DEVELOPMENT APPLICATION ASSESSMENT REPORT

Application Number:	DA2021/0237
----------------------------	-------------

Responsible Officer:	Adam Mitchell
Land to be developed (Address):	Lot 68 DP 16212, 123 Rickard Road NORTH NARRABEEN NSW 2101
Proposed Development:	Alterations and additions to a dwelling house including swimming pool
Zoning:	E4 Environmental Living
Development Permissible:	Yes
Existing Use Rights:	No
Consent Authority:	Northern Beaches Council
Land and Environment Court Action:	No
Owner:	Kimberley Jane Wright Thomas David Wright
Applicant:	Thomas David Wright

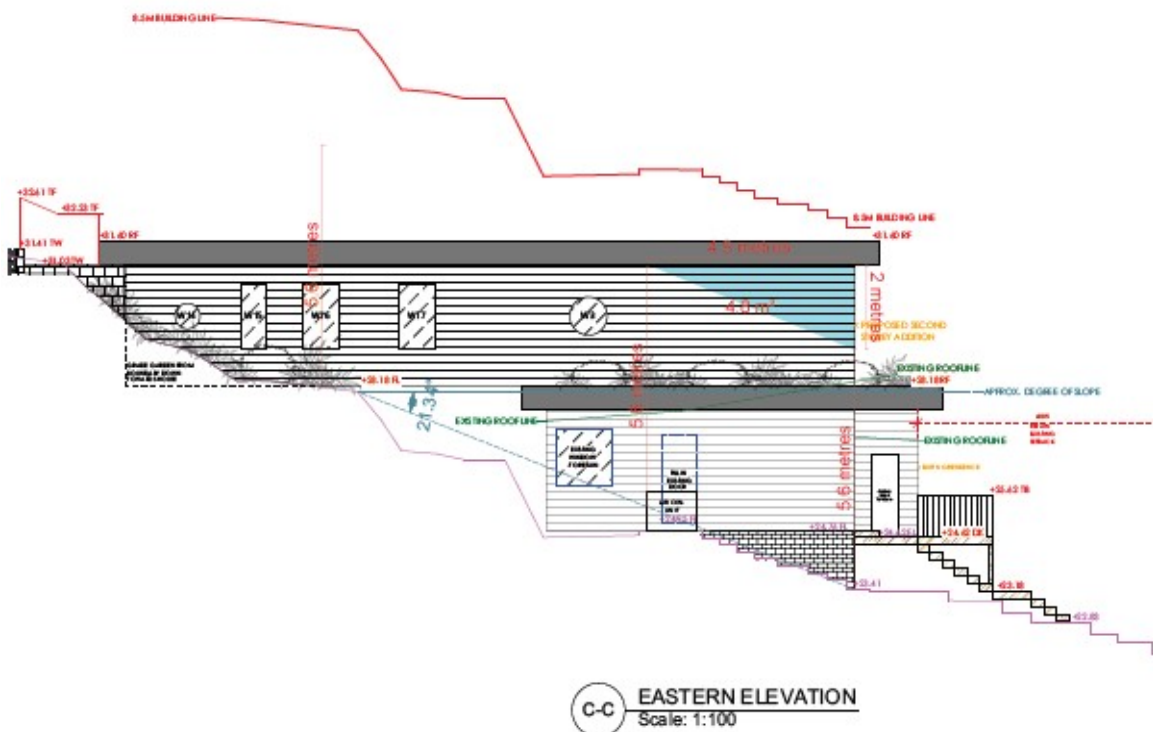
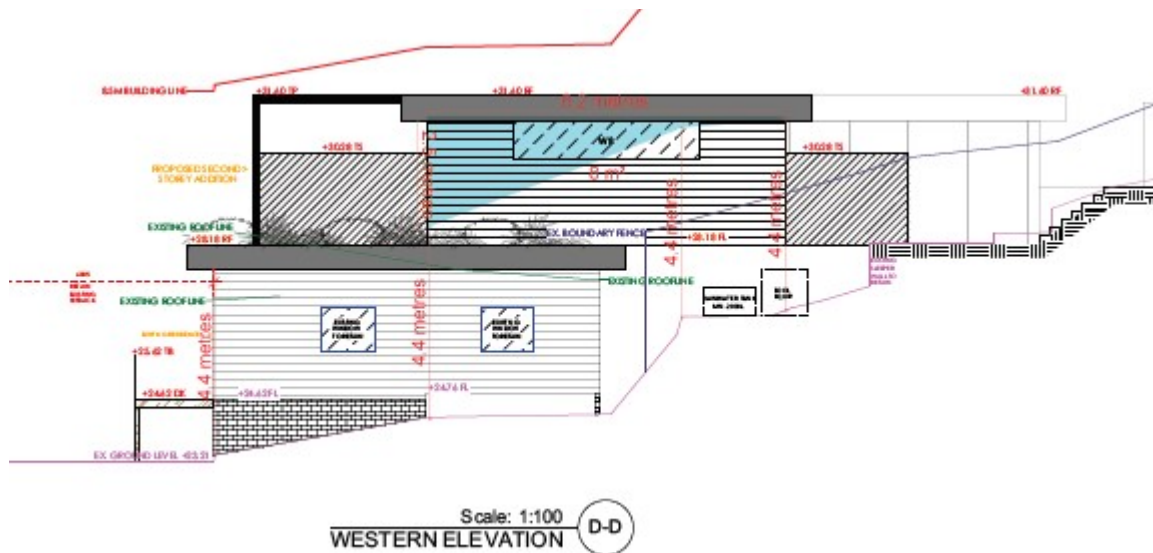
The P21 DCP prescribes a building envelope that applies to the flank elevations of a dwelling house. Part D11.9 allows Council to consider a variation for the addition of a second storey where the existing dwelling is retained, such as is proposed in this application. Both the northwestern and southeastern elevations of the proposed dwelling encroach the envelope for the dimensions stated in the Built Form Control table, and as shown in the below diagrams:
